ON LAND llc

5 KEY ISSUES at Lechmere Square

Critique of EOT Proposed Lechmere Station

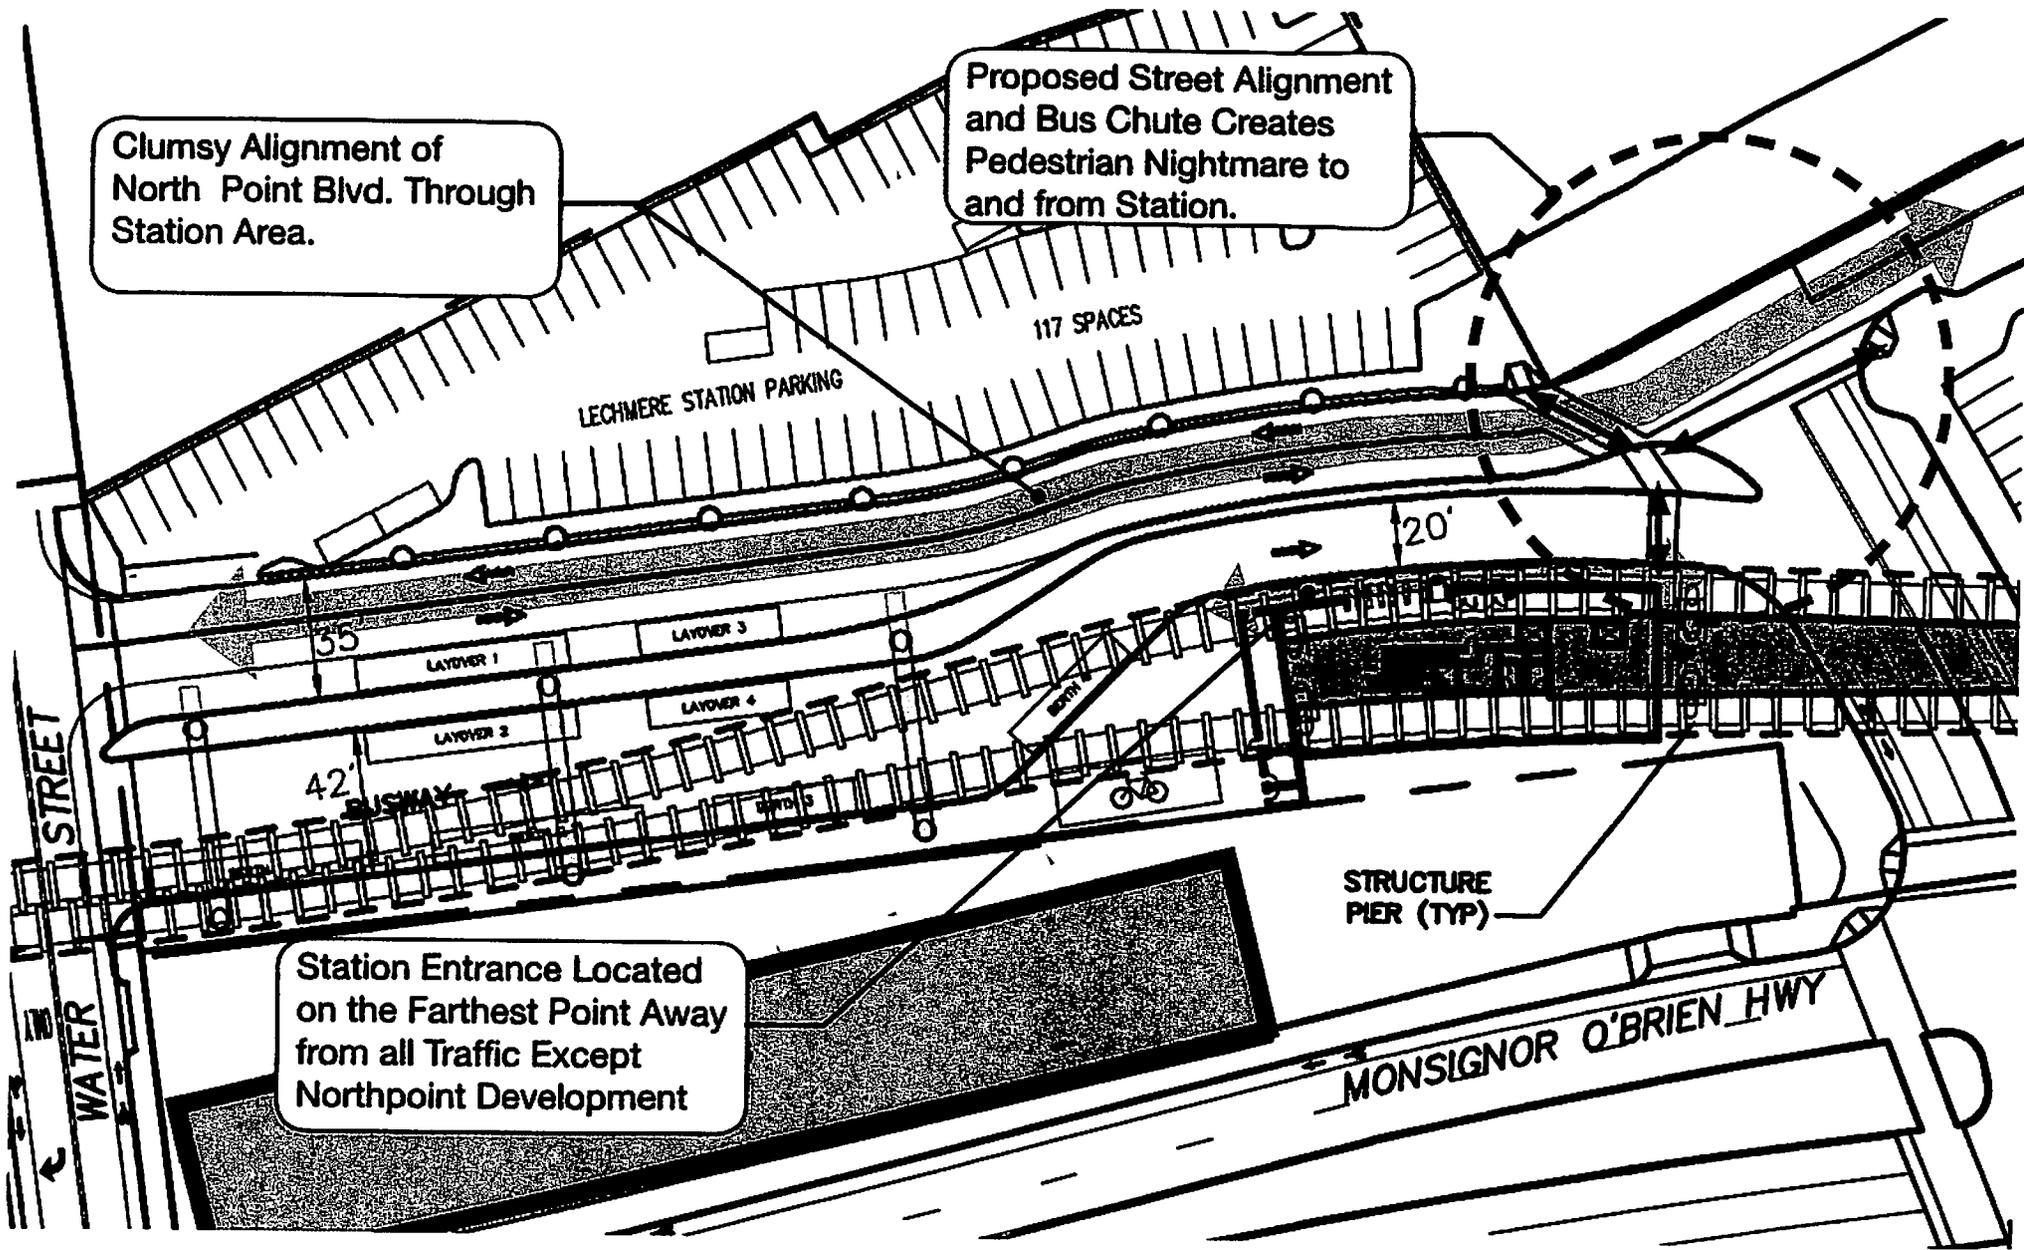
Proposed Lechmere Station has No Lobby- Charlie Card Services and Turnstiles Exposed to Elements. All of the Other Proposed Stations on the Green Line Extension have Lobbies and Therefore Interior Turnstiles and Charlie Card Stations.

Why is Lechmere Station Different?

Critique of EOT Proposed Lechmere Station

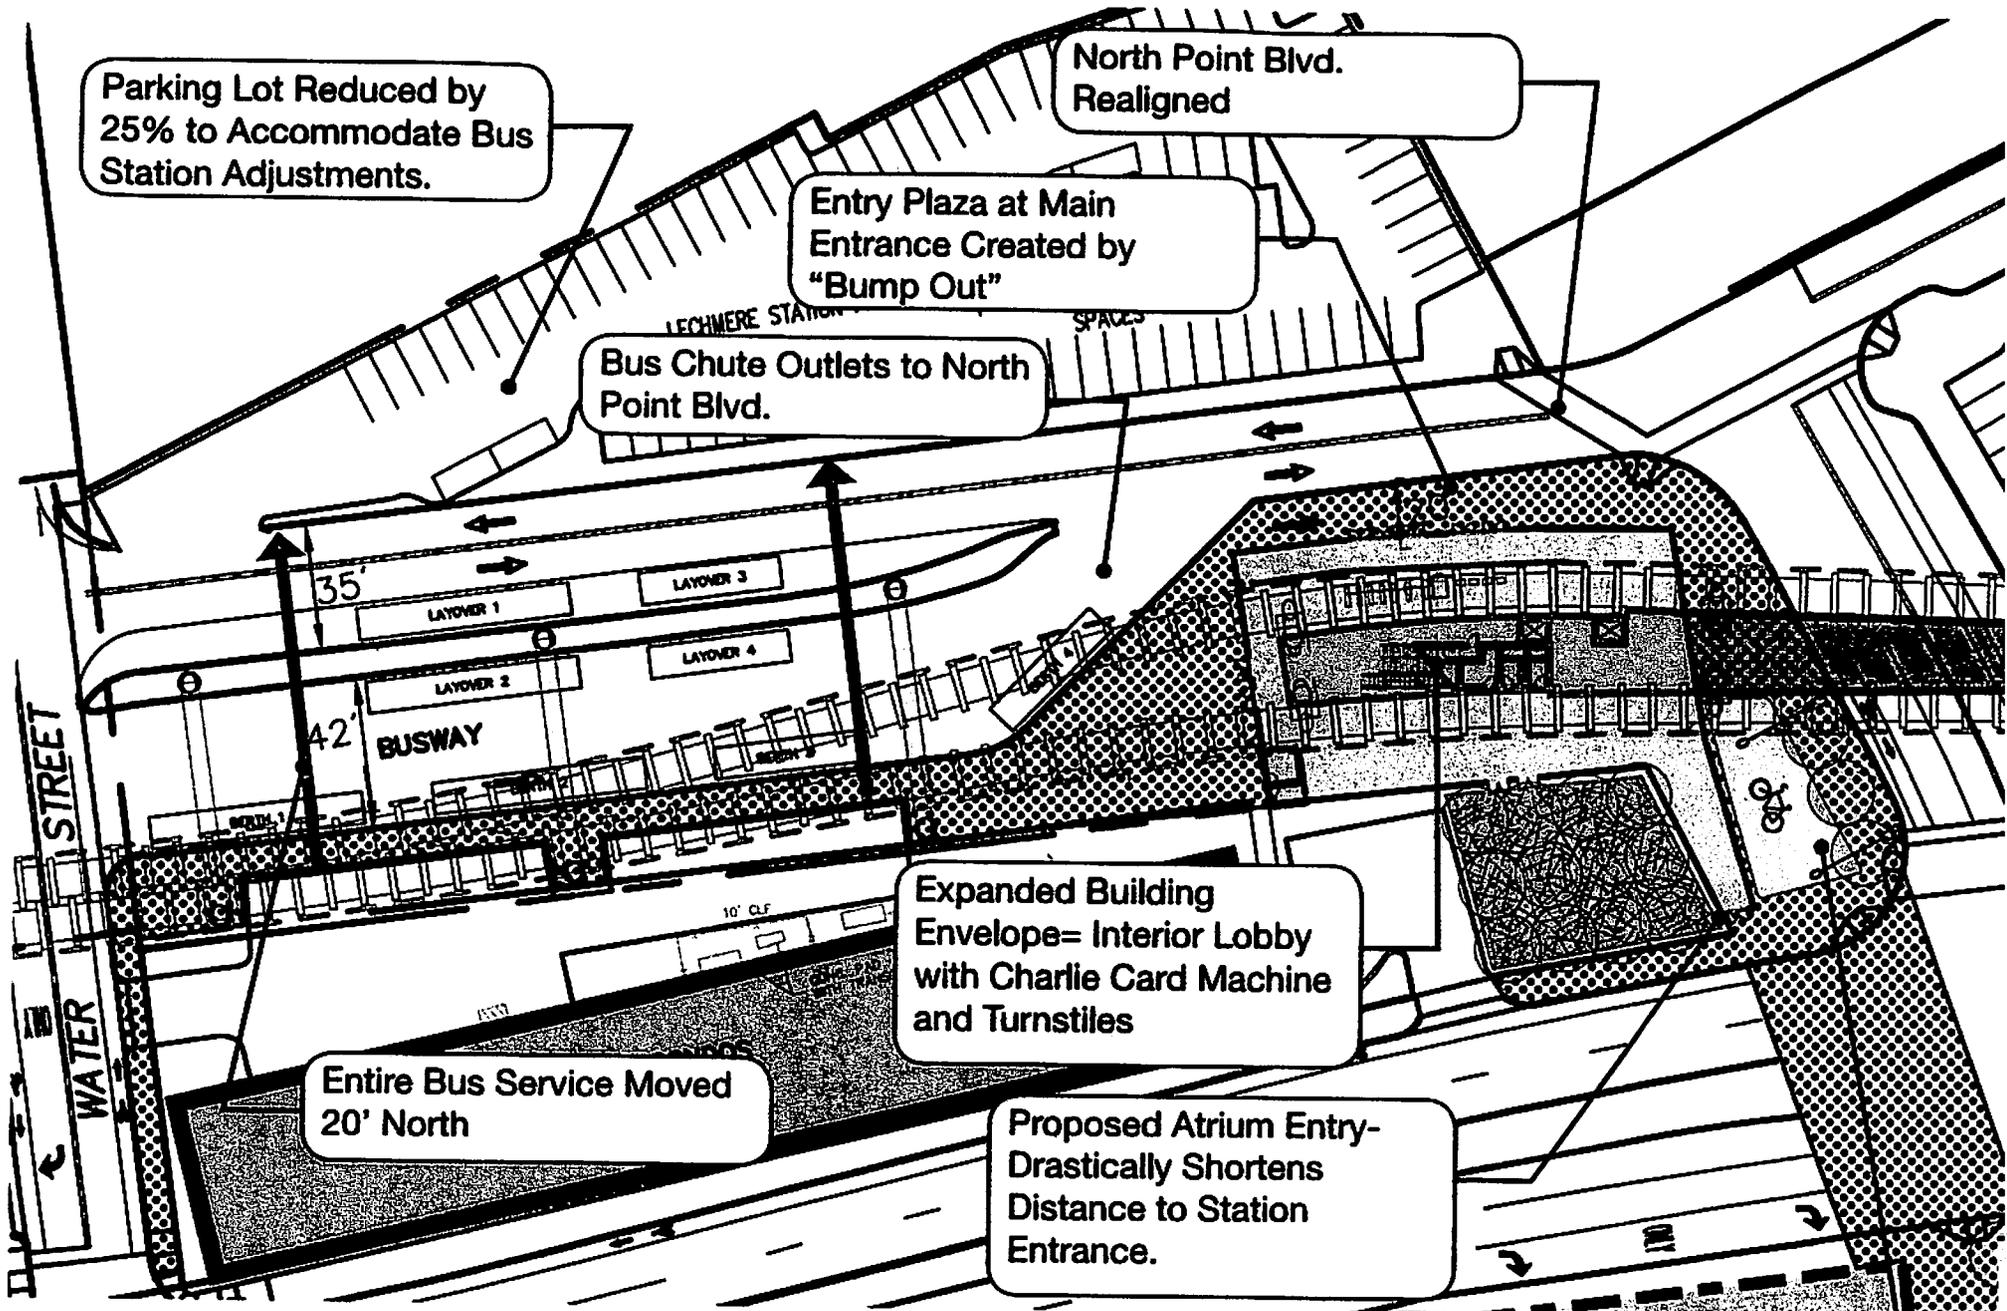
Clumsy Alignment of North Point Blvd. Through Station Area.

Proposed Street Alignment and Bus Chute Creates Pedestrian Nightmare to and from Station.

Station Entrance Located on the Farthest Point Away from all Traffic Except Northpoint Development
